CONTRACT ADDENDUM NO. 3

CITY OF REDMOND

OVERLAKE VILLAGE SOUTH DETENTION VAULT

Project No. 20020806

Structural Details
2 of 2

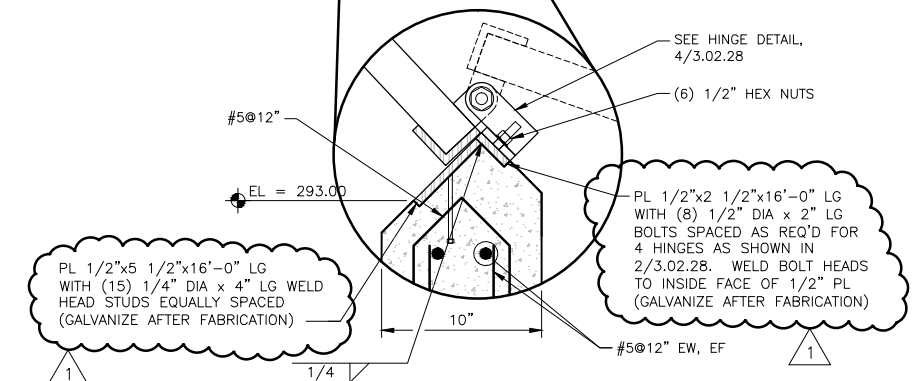
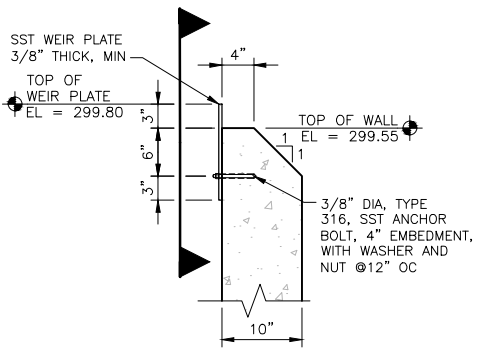
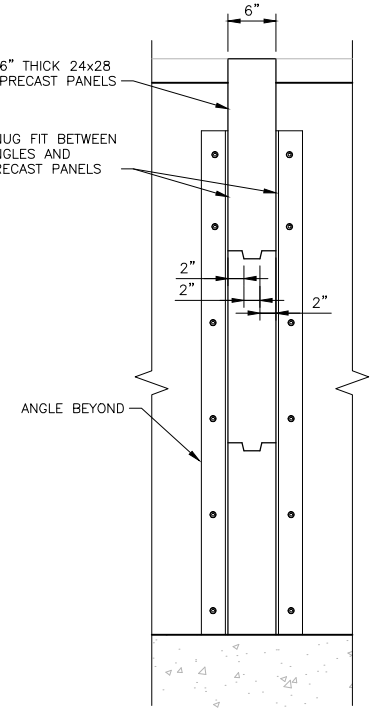
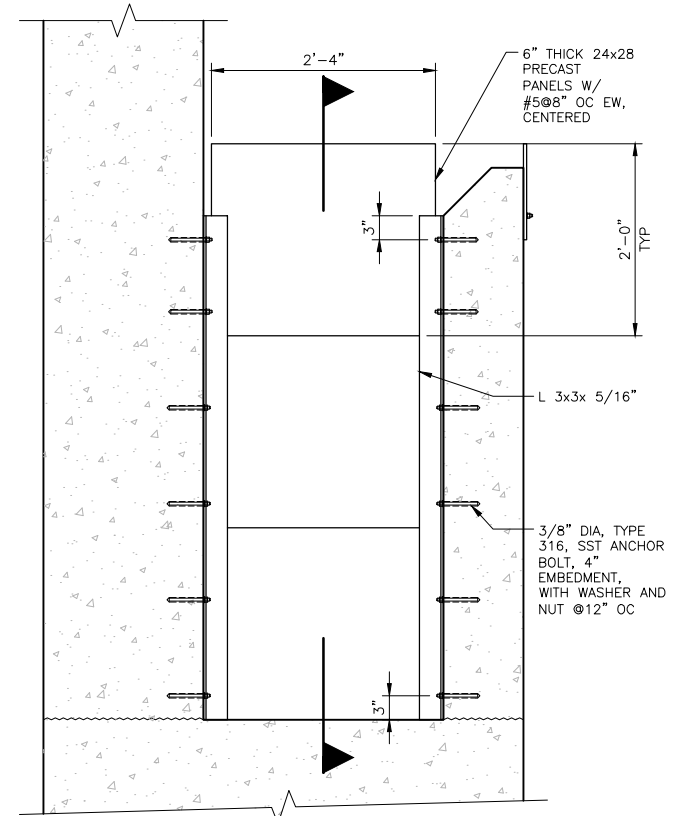
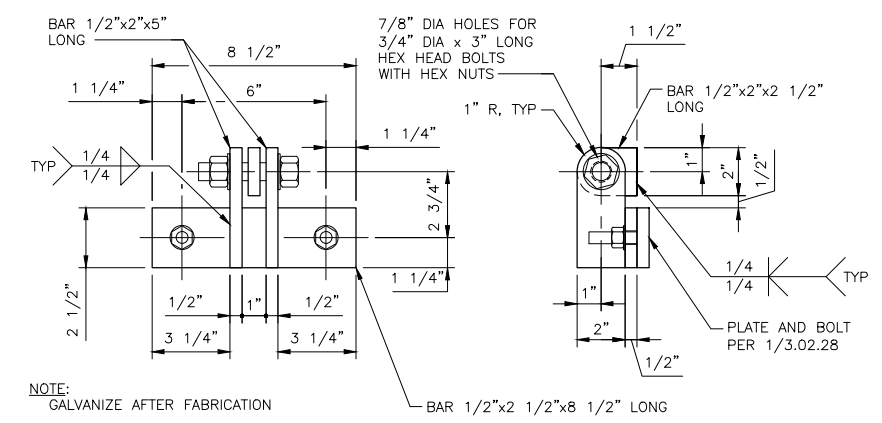
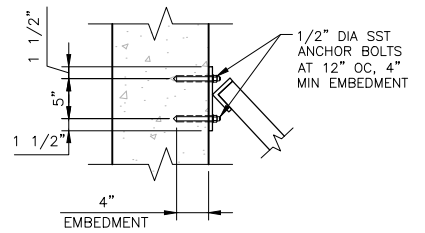
3.02.28	Structural Details 2 of 2	Revised Notes in Detail 1 on Sheet 3.02.28
---------	------------------------------	--
